INDEX OF STRUCTURAL DRAWINGS

**KUHIO HIGHWAY SHORT-TERM
IMPROVEMENTS KUAMOO ROAD
TO TEMPORARY KAPAA BYPASS ROAD**
Fed. Aid Proj. No. NH-056-1(50)

"AS-BUILT"

CULVERT EXTENSION SECTIONS

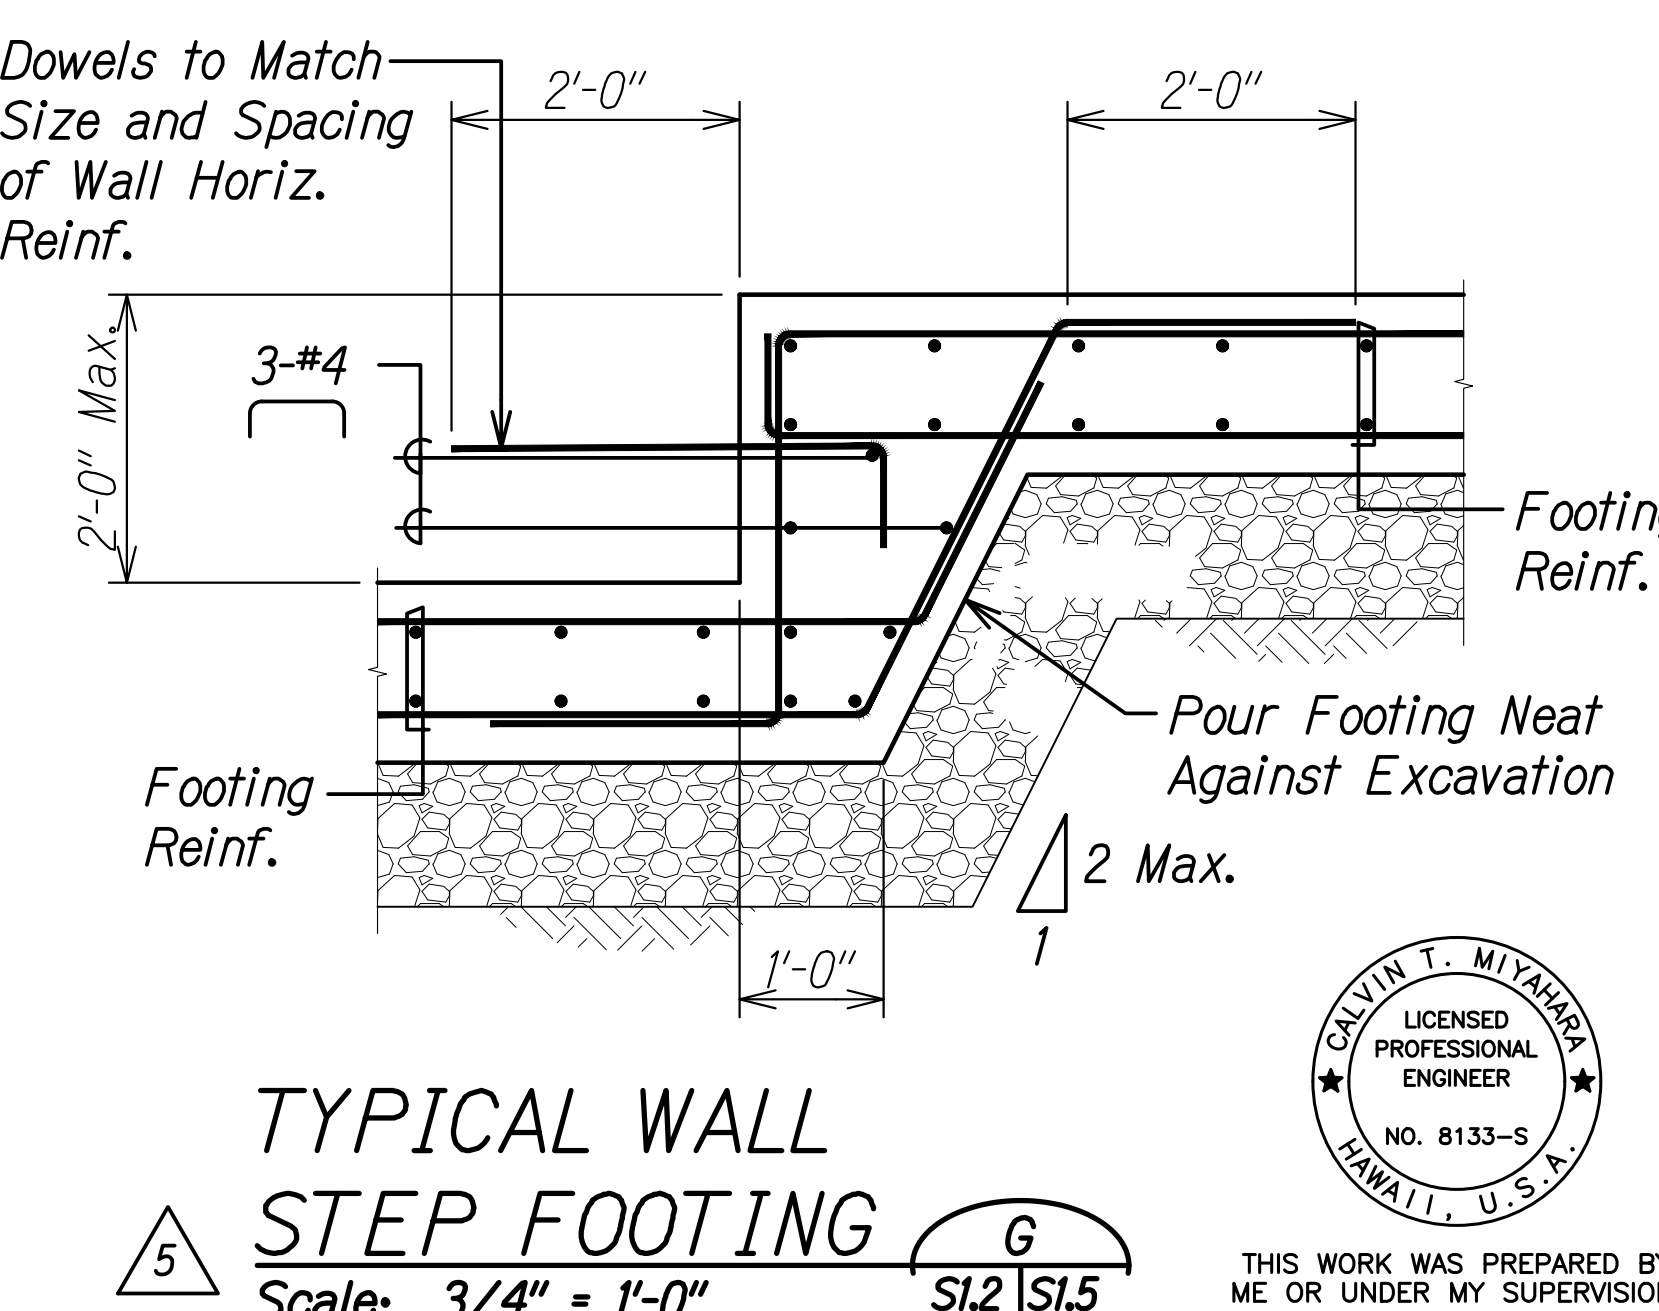
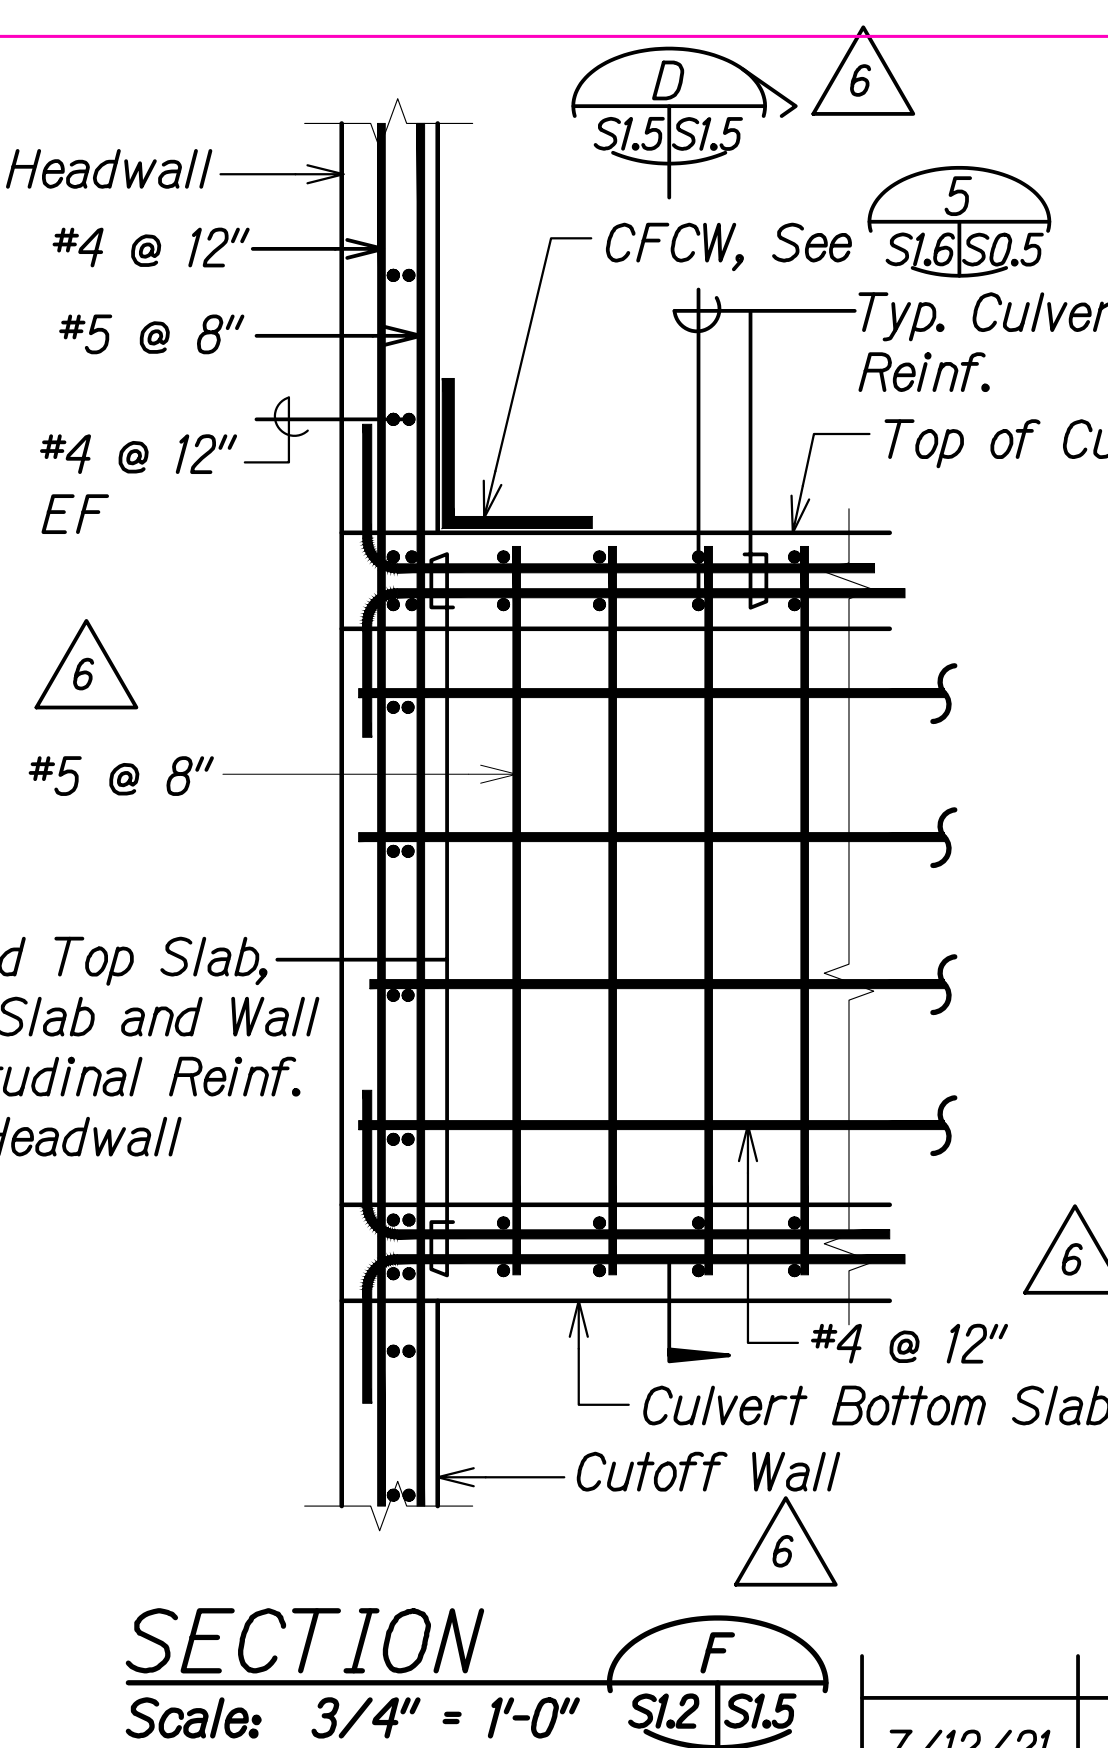
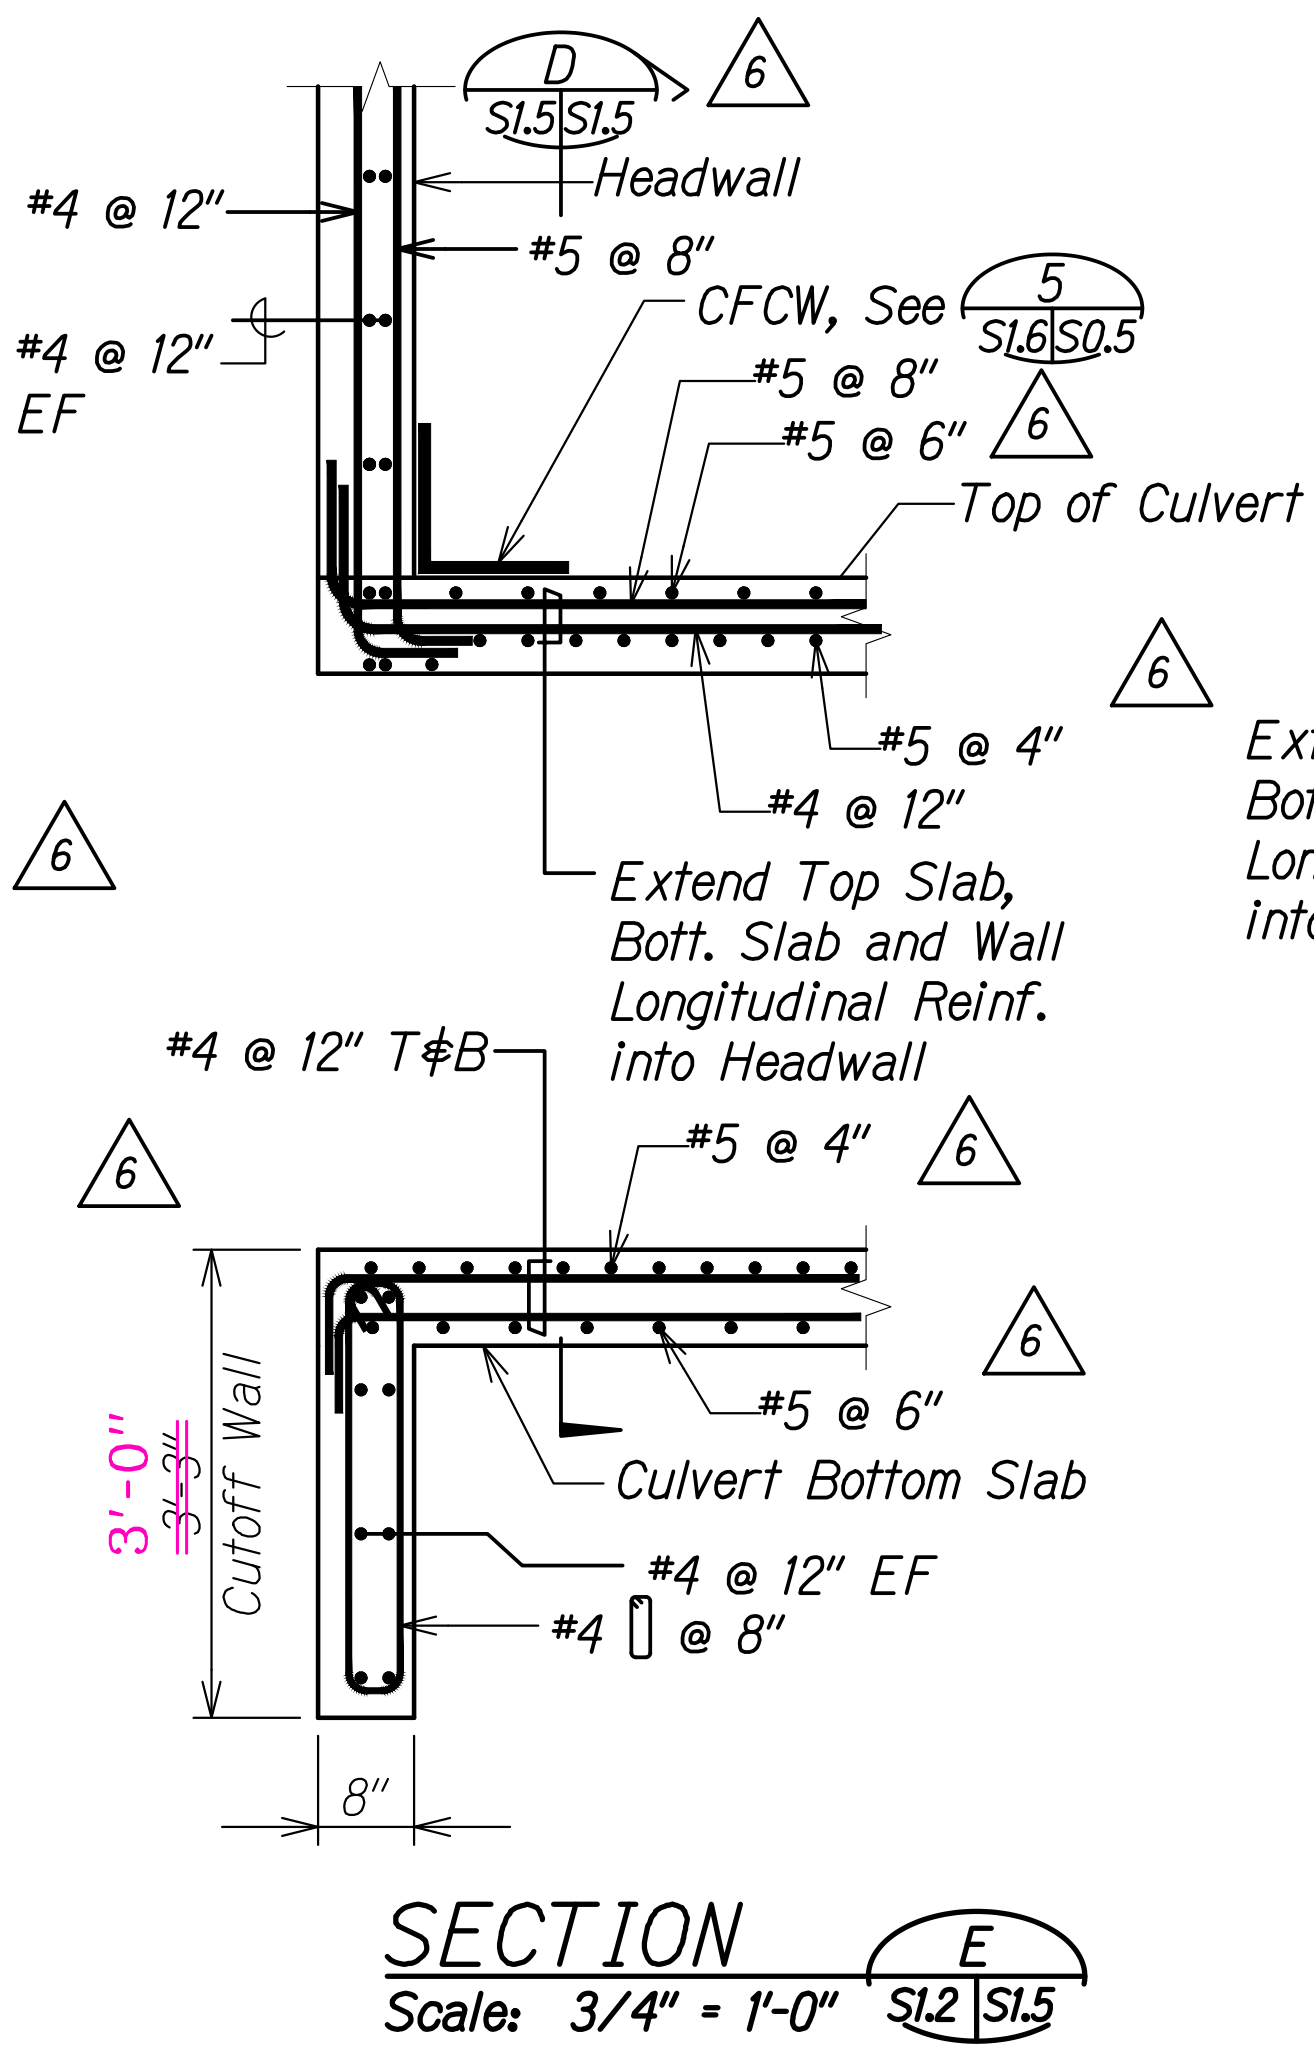
| DATE | REVISION |
|----------|---|
| 7/12/21 | 6 C.O. Revised headwall sections. |
| 7/5/21 | 5 C.O. Revised and new EB headwall sections. |
